CITY OF GLENDALE, CA

DESIGN REVIEW STAFF REPORT – MULTI FAMILY

July 11, 2024 <i>Decision Date</i>	1038 Irving Avenue <i>Address</i>
Administrative Design Review (ADR) <i>Review Type</i>	5624-012-001 <i>APN</i>
PADR-003134-2024 <i>Case Number</i>	Harry Akopian <i>Applicant</i>
Shoghig Yepremian, Planner <i>Case Planner</i>	Artour Babayans <i>Owner</i>

To construct a detached, two-story, 1,120 square-foot residential dwelling unit (Unit A) and a detached, two-story, 1,358 square-foot residential dwelling unit (Unit B) at the rear of an 8,222 square-foot lot developed with a 1,036 square foot single family dwelling (constructed in 1925), located in the R2250 (Medium Density Residential) zone. The existing single-family dwelling will remain on the site without modifications or changes. However, the existing non-conforming 341 square-foot detached garage servicing the single-family residence will be demolished to accommodate the construction of two proposed detached dwelling units at the rear.

1/4" = 1'-0"

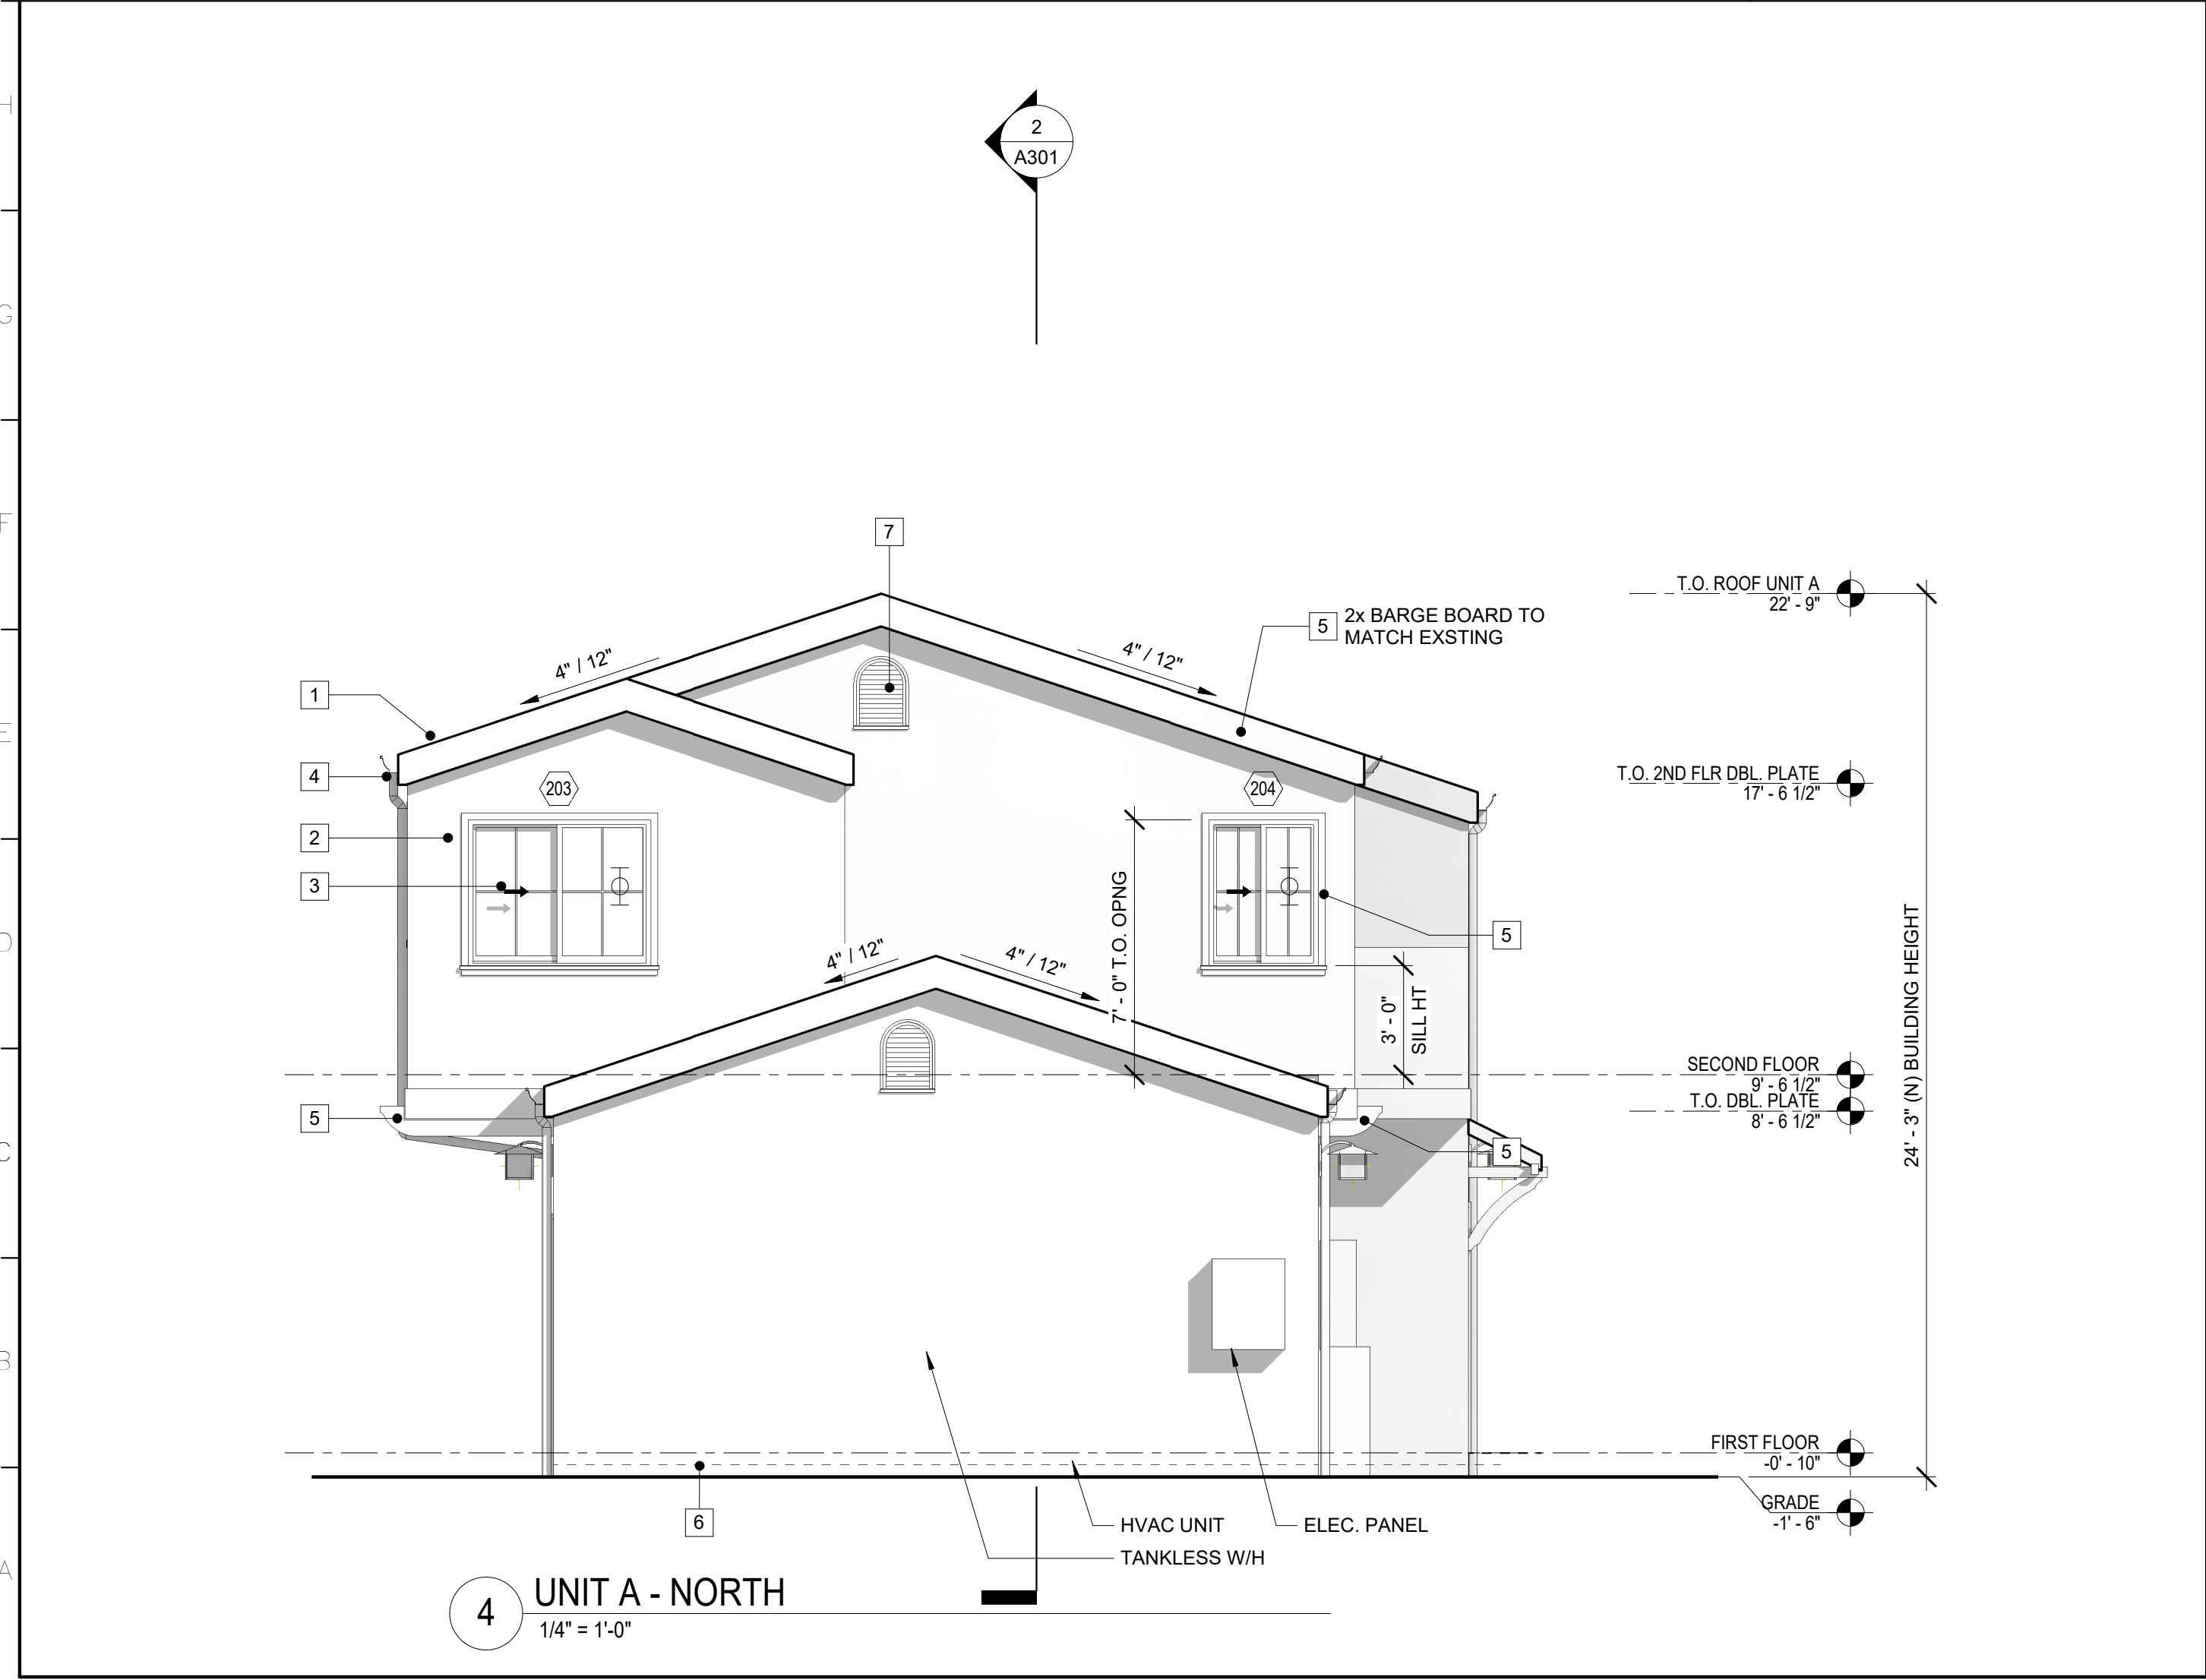
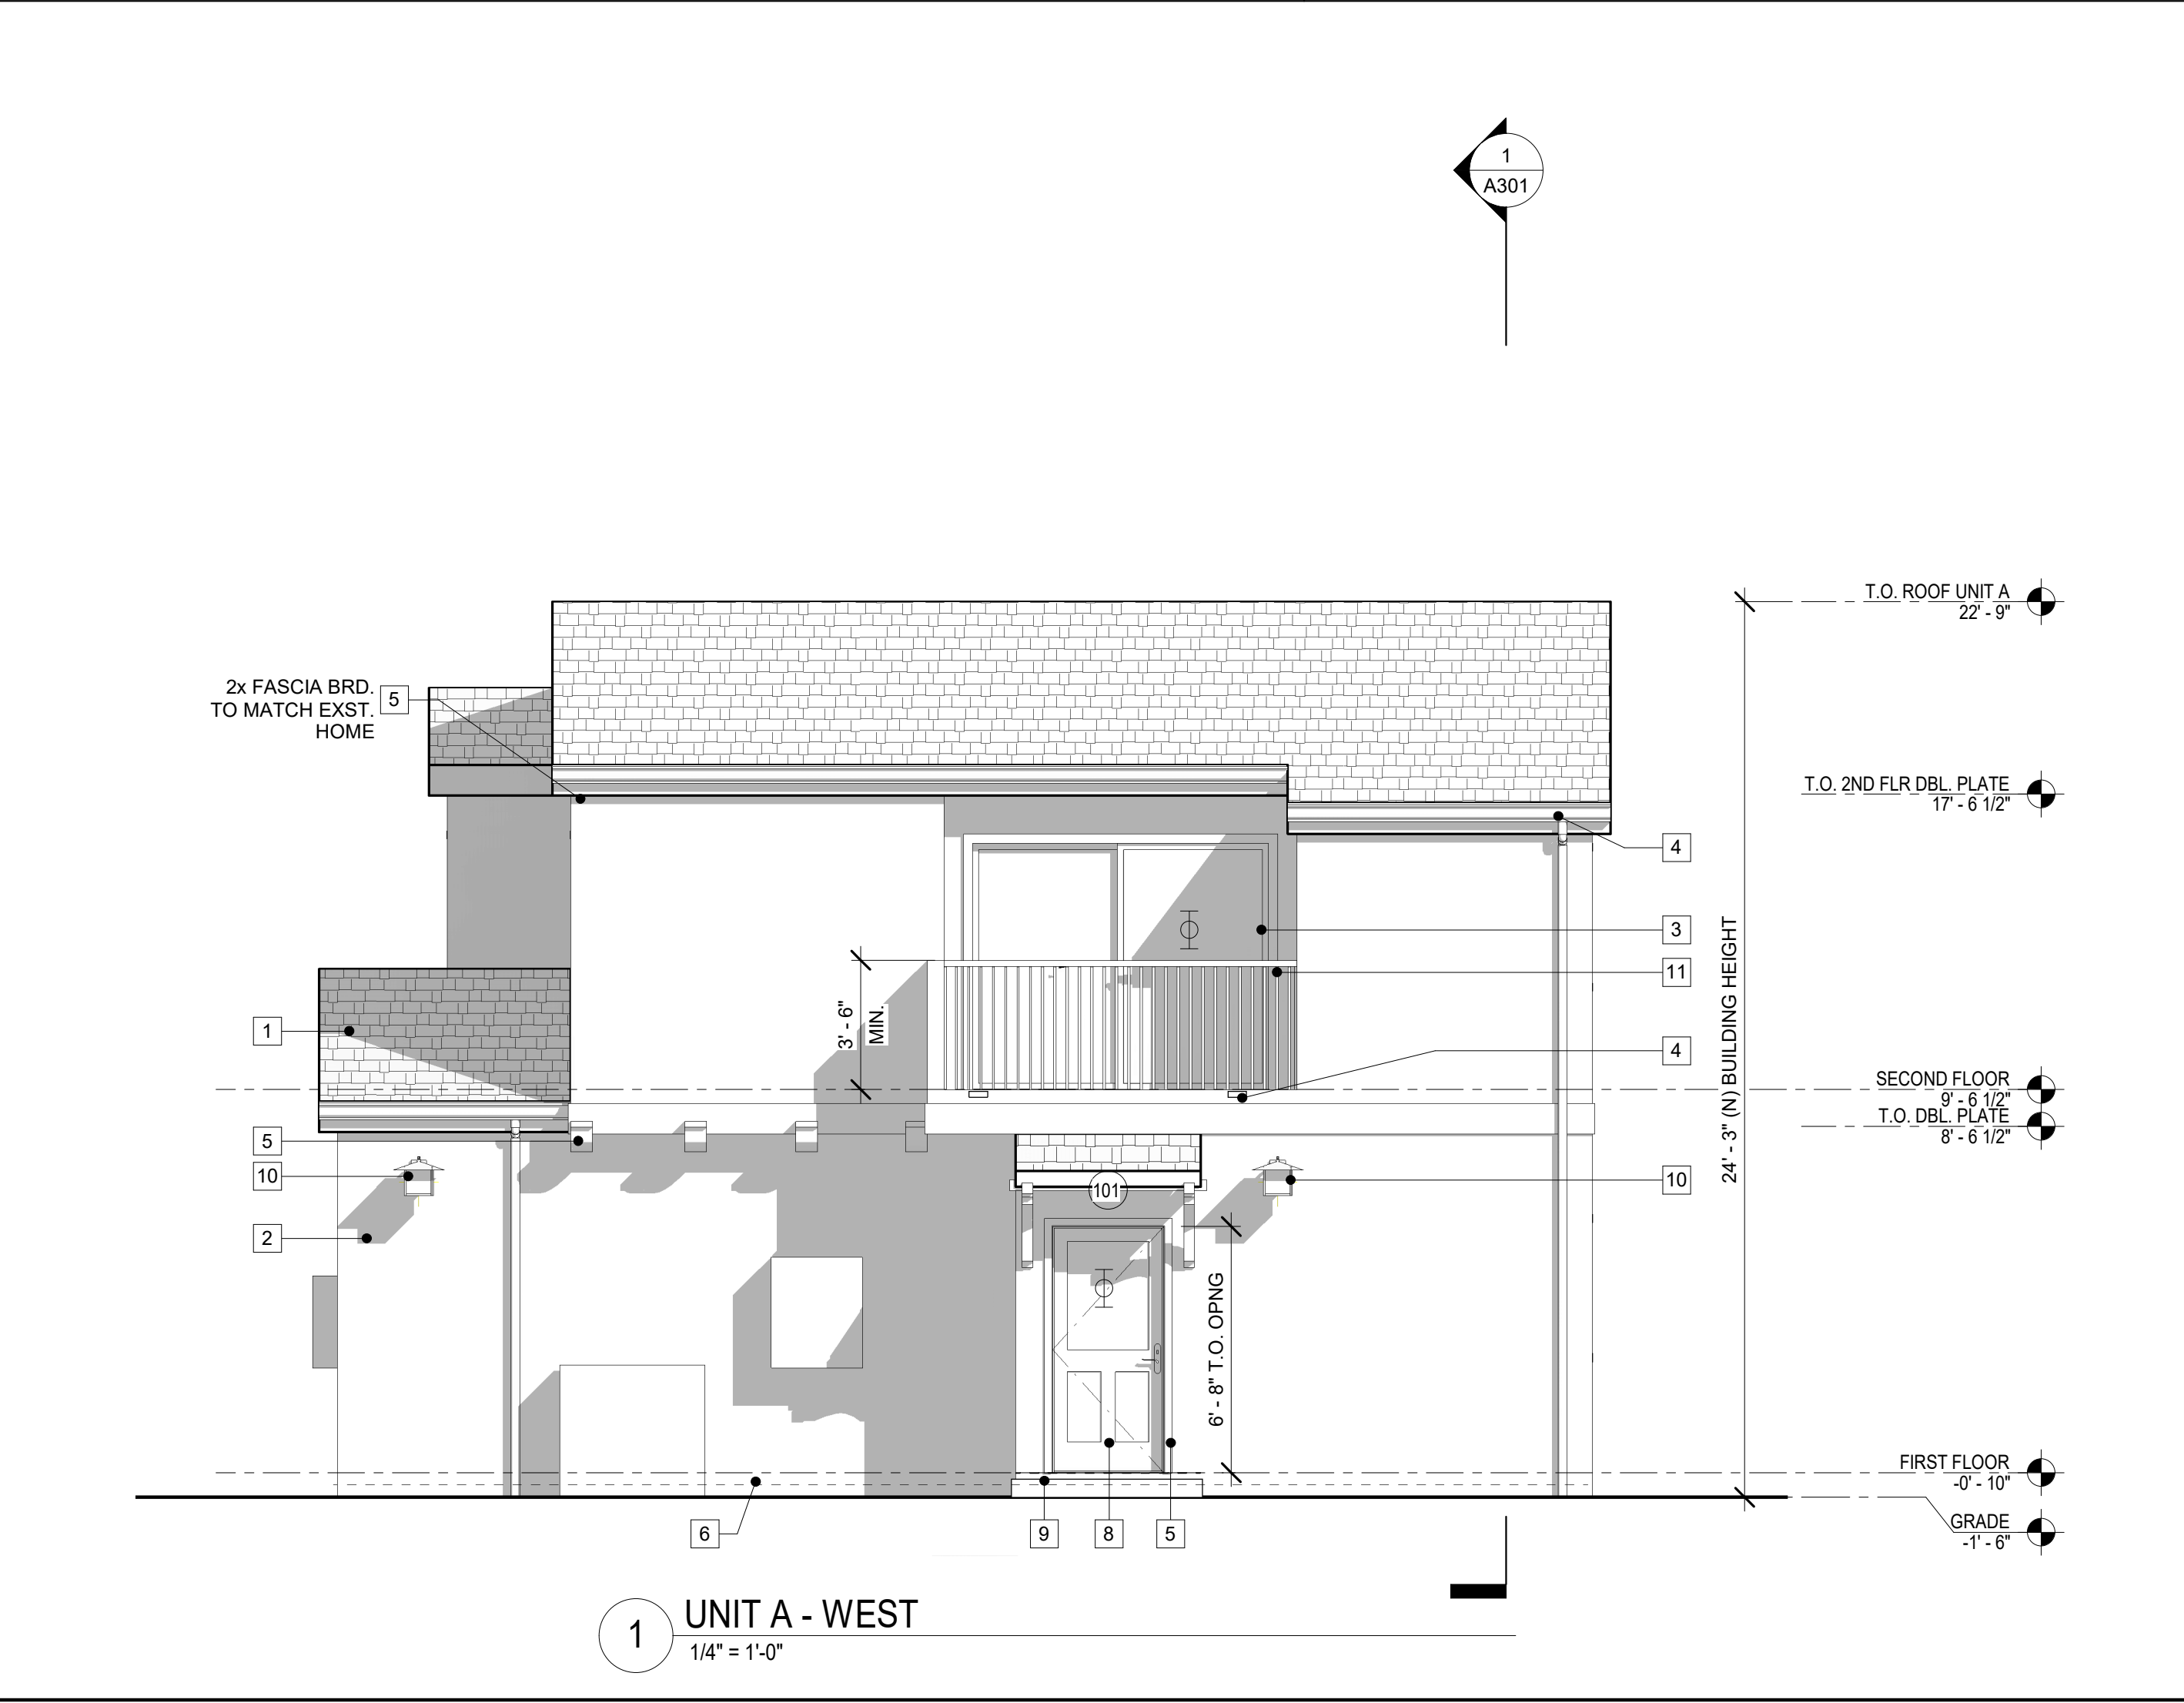
Both of the new units are located at the rear of the property and not in direct view from the street. The stucco finish for the new units will match the front house exterior color. Guidelines encourage a variety of materials in lieu of stucco alone. Staff recommends the application of sidings at the second level gables to provide a variety of materials.

- Include decorative paving materials for the driveway, walkways and common open space areas.
- Add siding at the second level gables to provide a variety of materials.
- The exterior stucco finish to have smooth finish throughout the units.
